<input type="checkbox"/> Sidewalk Waiver (Form V2)	
SITE PLANS	<input type="checkbox"/> Waiver to IDO (Form V2)	APPEAL
<input type="checkbox"/> DRB Site Plan (Form P2)	<input type="checkbox"/> Waiver to DPM (Form V2)	<input type="checkbox"/> Decision of DRB (Form A)
BRIEF DESCRIPTION OF REQUEST		
No change to the site plan or footprint to the three structures. Modified glazing and shade structure to south and east elevations of Building D. Garage and operable windows are incorporated into the design of the future restaurant.

AVANYU NORTH - BUILDINGS D, E & F

AVANYU NORTH - BUILDING D

Re: Request for a Minor Amendment to the approved Site Development Plan for Building Permit for the proposed new construction at 2500 12th Street NW

1/8" = 1'-0"

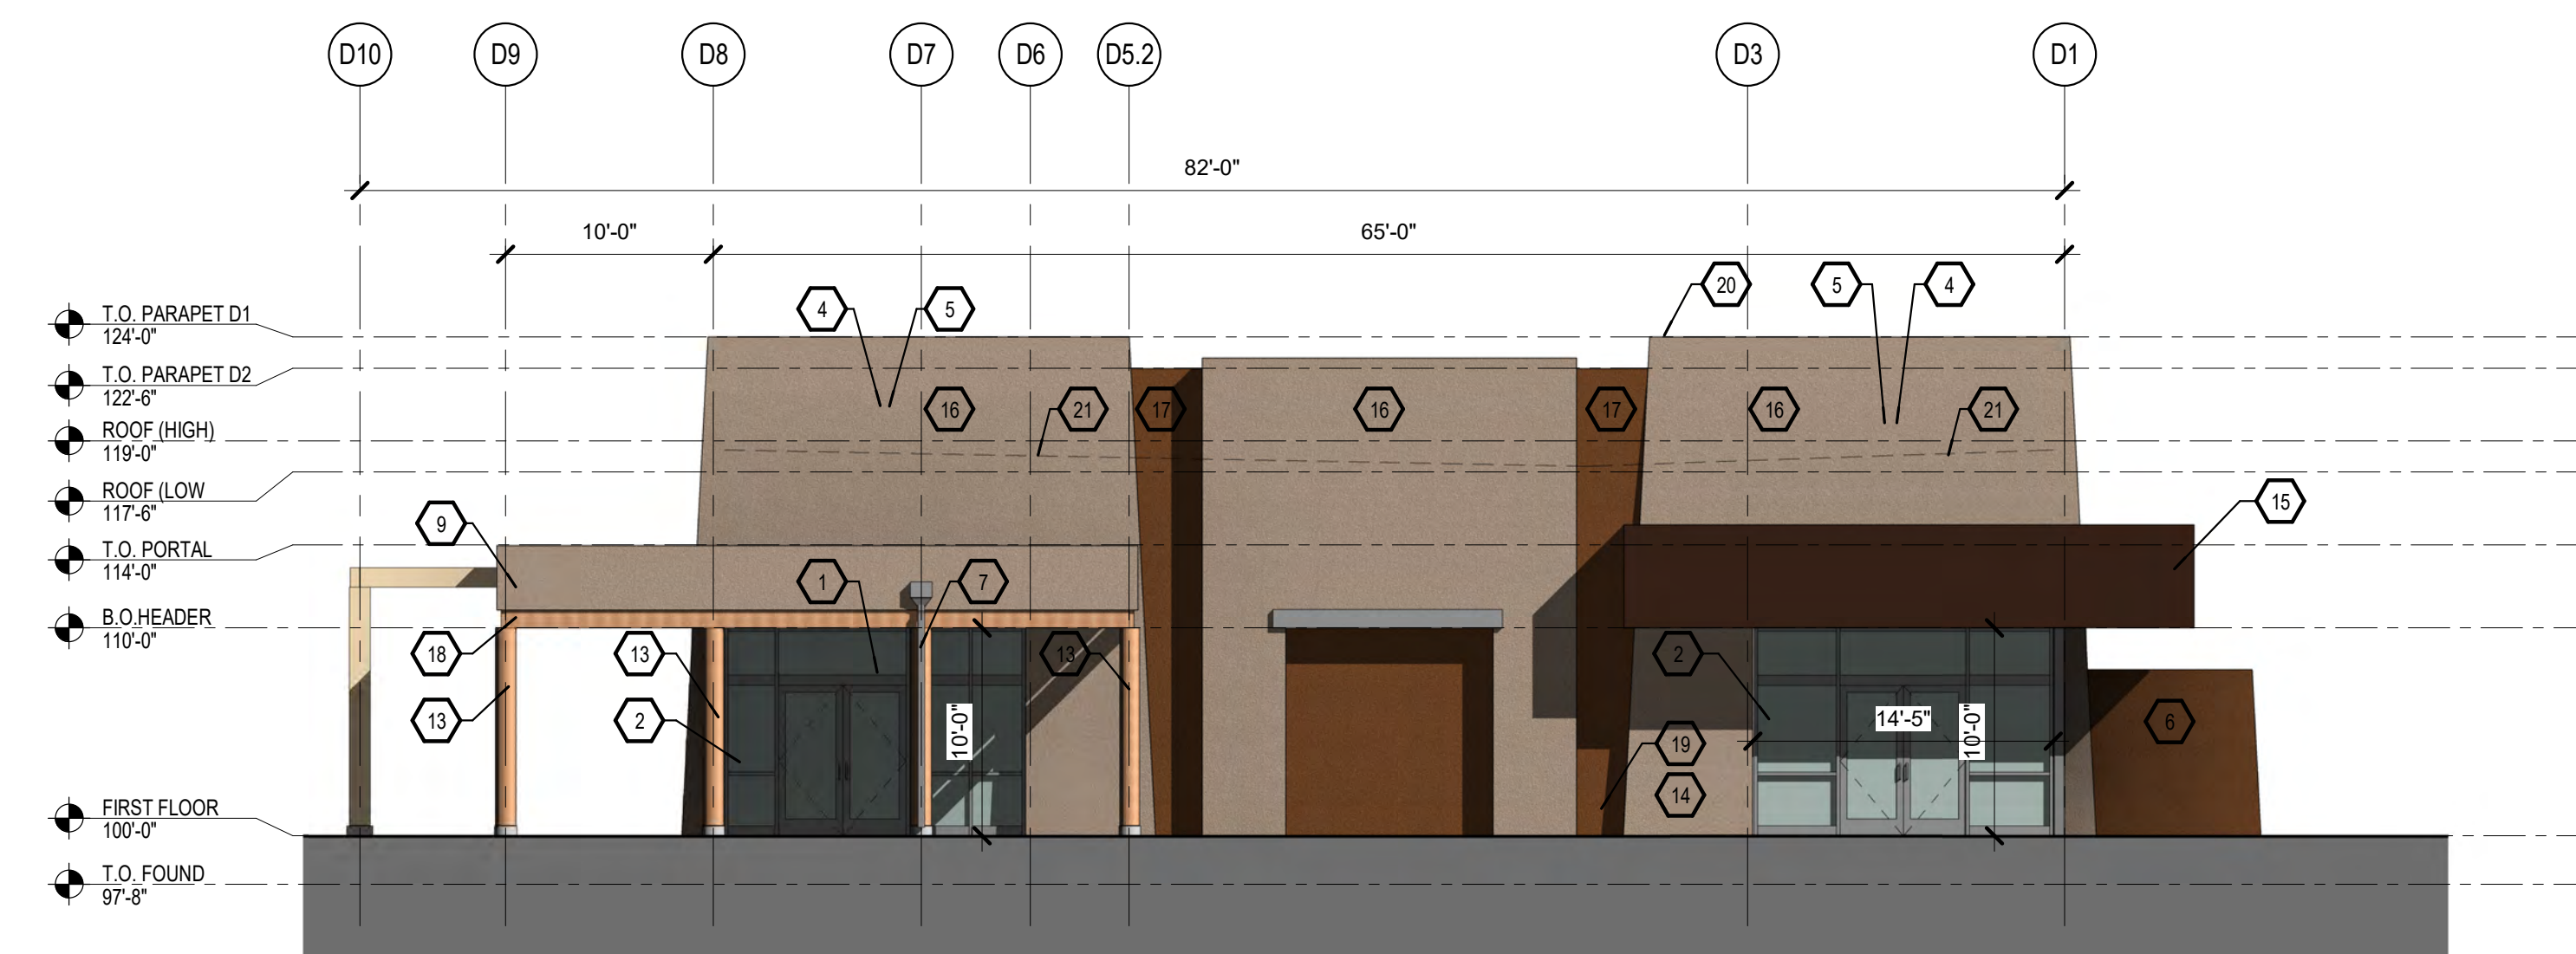
- 20. PAINTED METAL COPING.
- 21. ROOF SLOPE.
- 22. OPERABLE GLAZING / ROLL UP - GARAGE DOOR TYPE.

EXTERIOR BUILDING ELEVATIONS

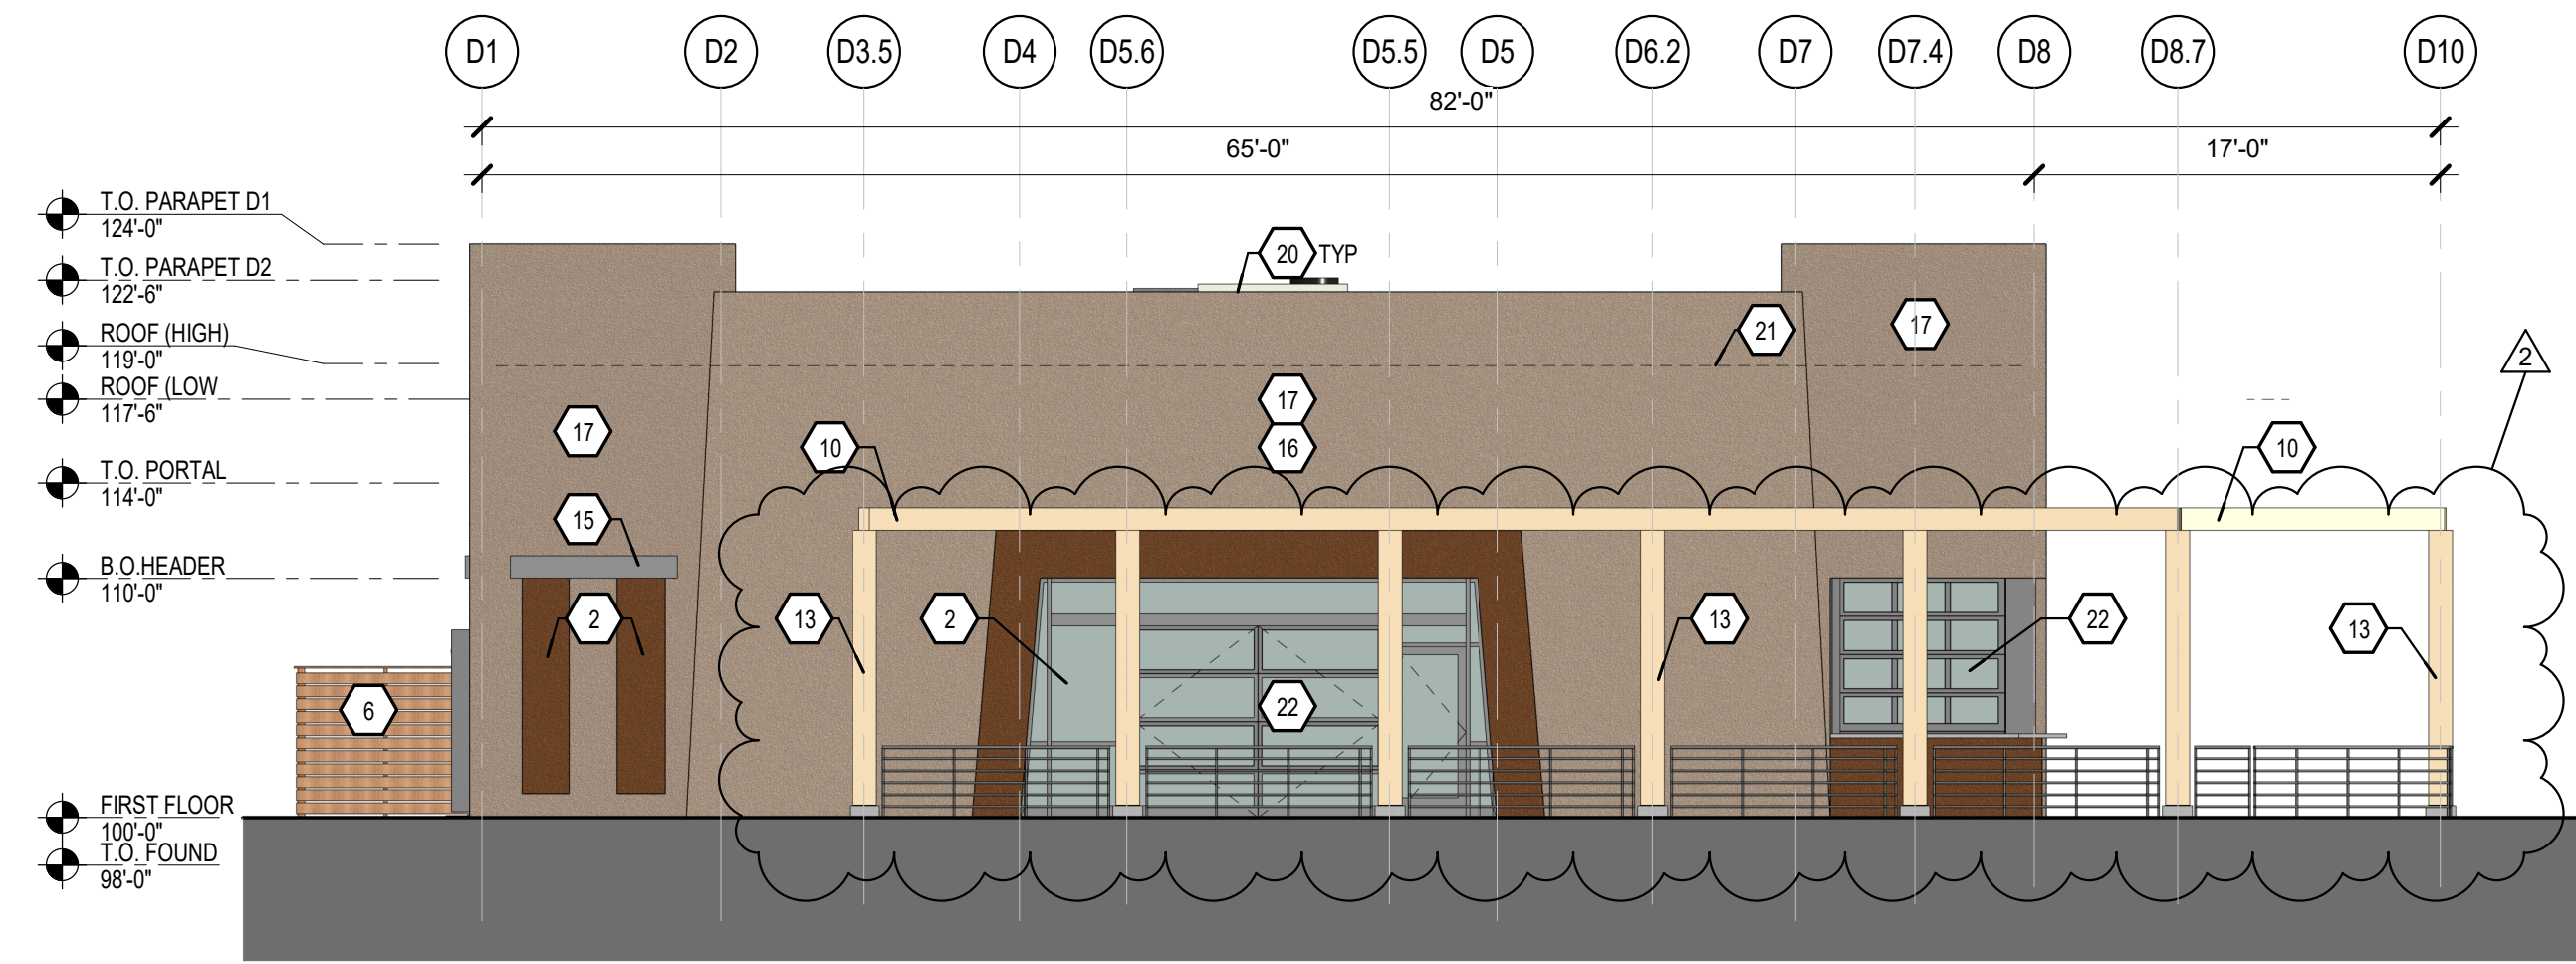
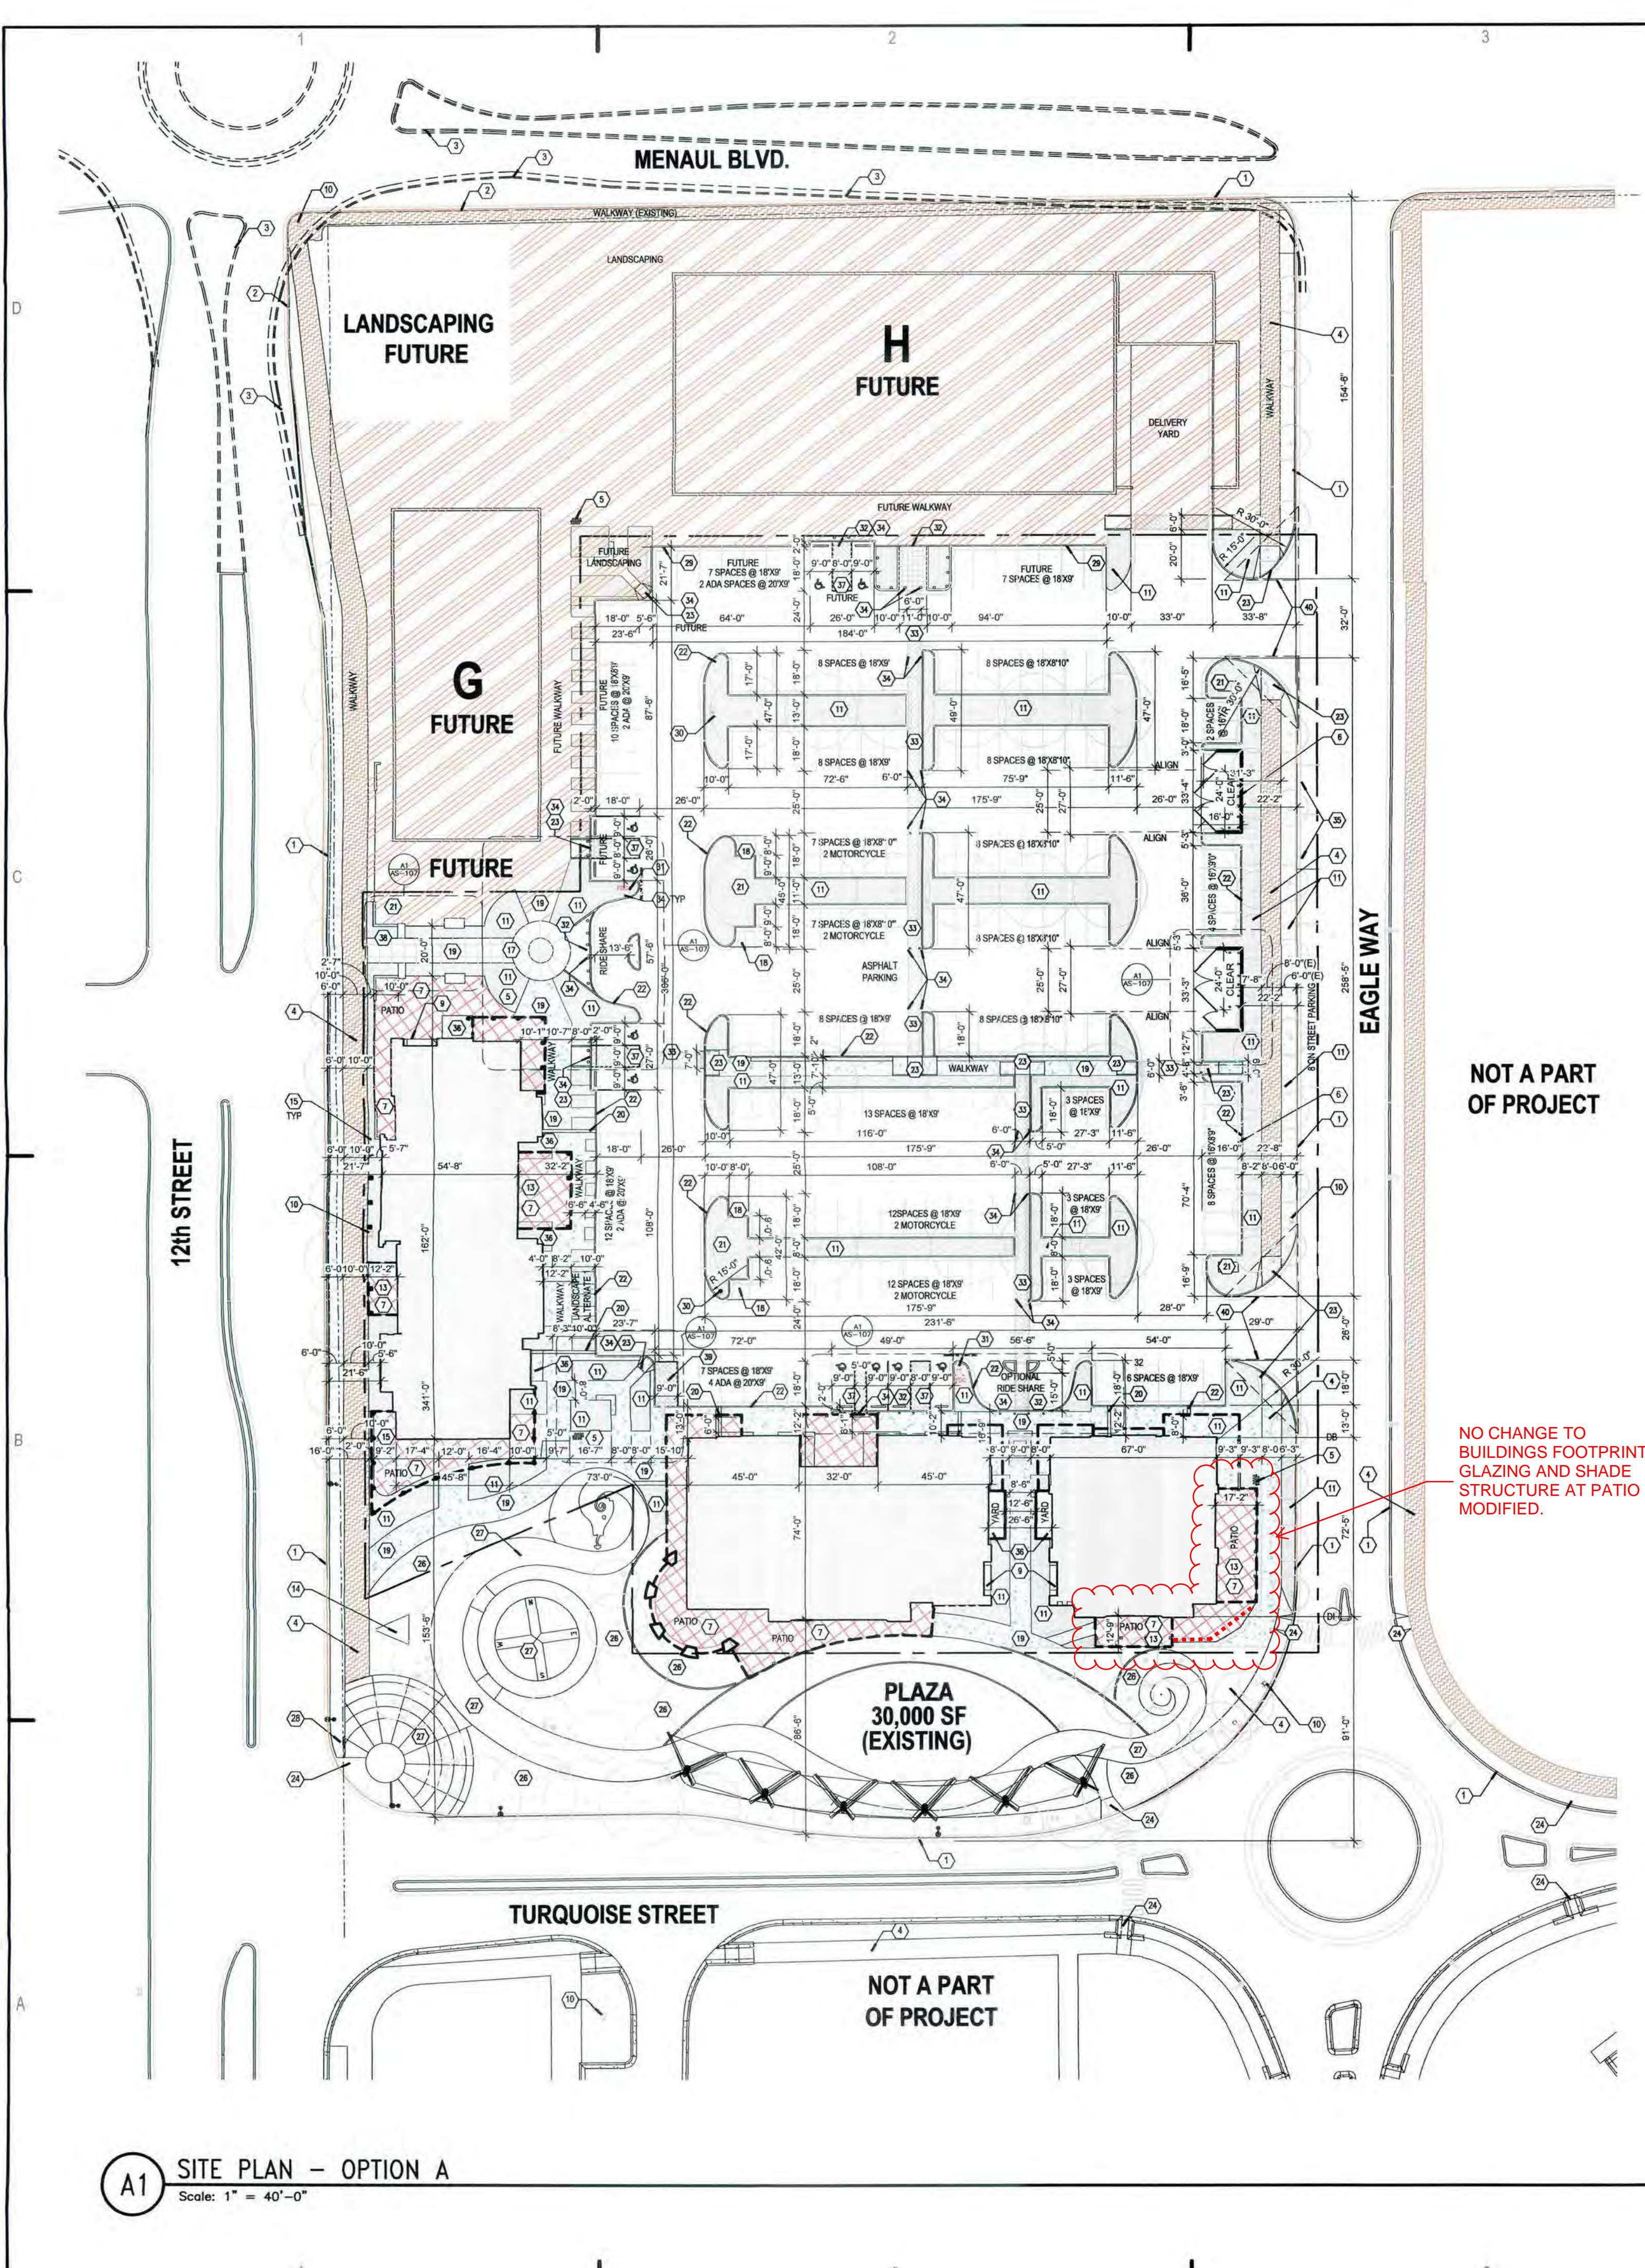
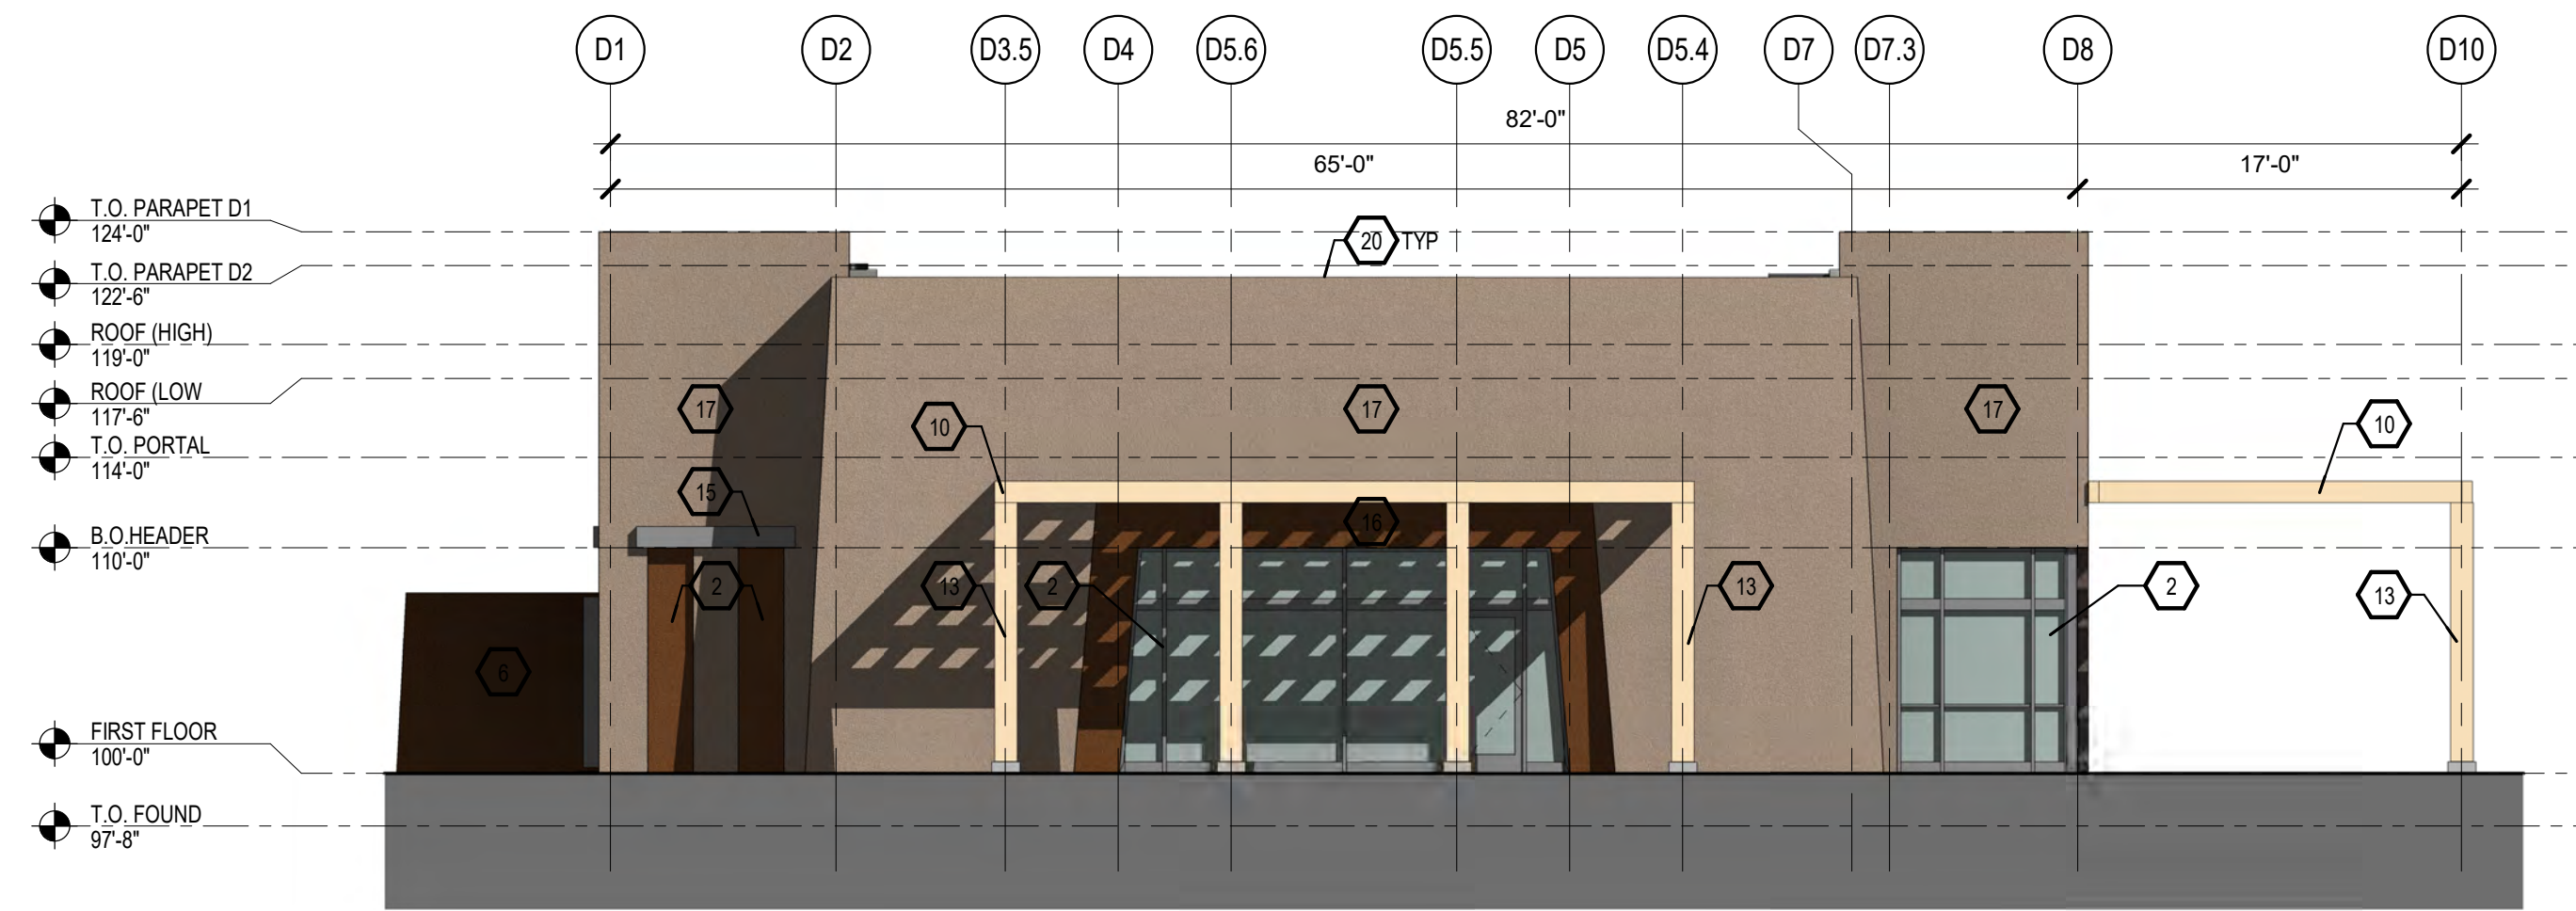
- 18. WOOD BEAM
- 19. ROOF DRAIN AND OVERFLOW AT PORTAL - INSTALL SPLASH BLOCK BELOW.
- 20. PAINTED METAL COPING.
- 21. ROOF SLOPE
- 22. OPERABLE GLAZING / ROLL UP - GARAGE DOOR TYPE
